Classification:
 WT10-004a

Reference:
 ITB10-050a

TPMS COMPONENTS NOT INTERCHANGEABLE

For example:

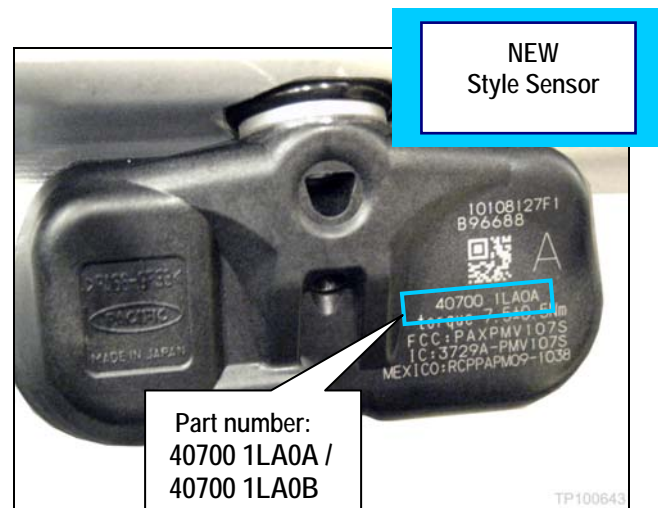
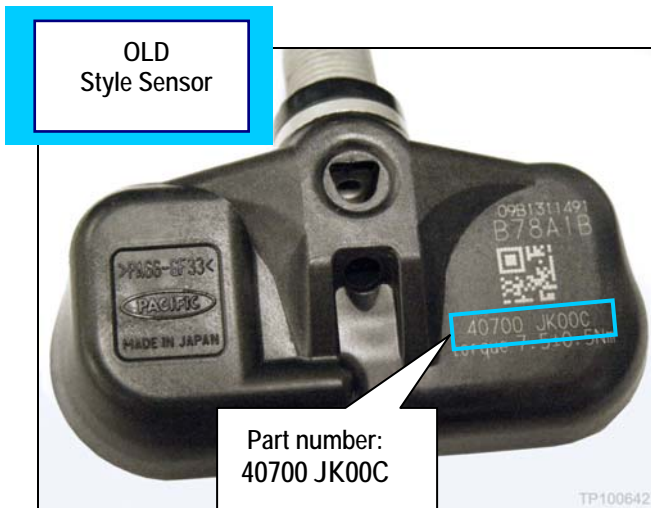
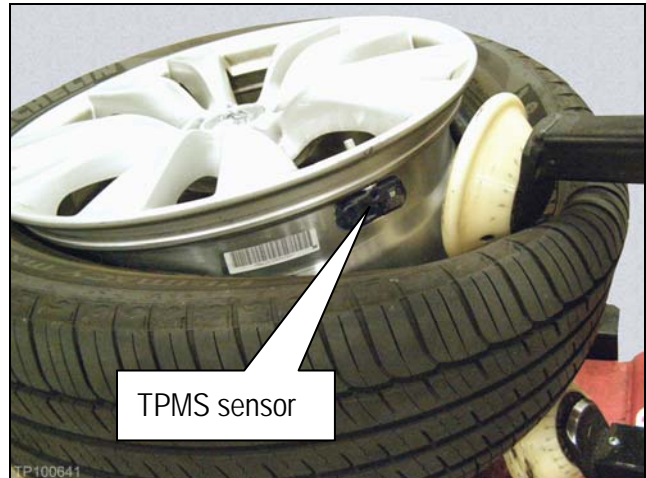
- These changes **do not affect** the overall function of the TPMS.
- These changes **do affect** the interchangeability of parts.

- **Full wheel assemblies** (wheel and tire assemblies with TPMS) **cannot be swapped** between old style sensor-equipped and new style sensor-equipped vehicles.

- New style and old style TPMS components are not compatible and cannot be interchanged.
- Swapping of new style and old style components will cause the TPMS to stop operating correctly.
